YEAR
1994

MODEL
INTEGRA

BULLETIN NO.
94-003

RECALL: Automatic Transmission Shift Linkage

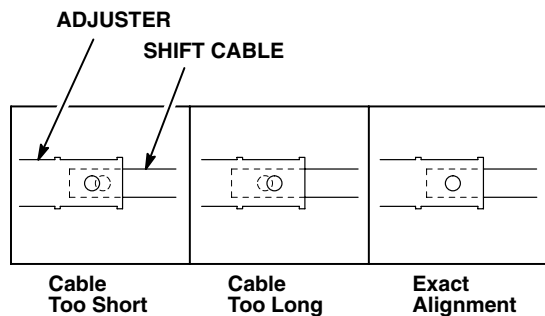
3. Remove the adjuster pin from the shift linkage and discard it.

4. Install the new adjuster pin.
 - If the pin feels like it is binding, continue to step 5 to check the shift linkage adjustment.
 - If the pin fits without binding, go to step 6.

Replace the transmission shift linkage adjuster pin with the new part listed under PARTS INFORMATION.

Adjuster pin: P/N 54363-689-981

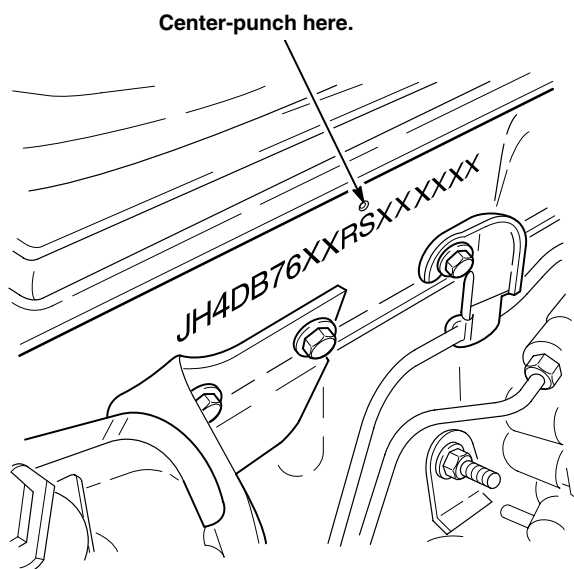
- Remove the adjuster pin. If the holes in the shift cable and the adjuster are not perfectly aligned, loosen the locknut and turn the adjuster to align the holes. Tighten the locknut and reinstall the adjuster pin.
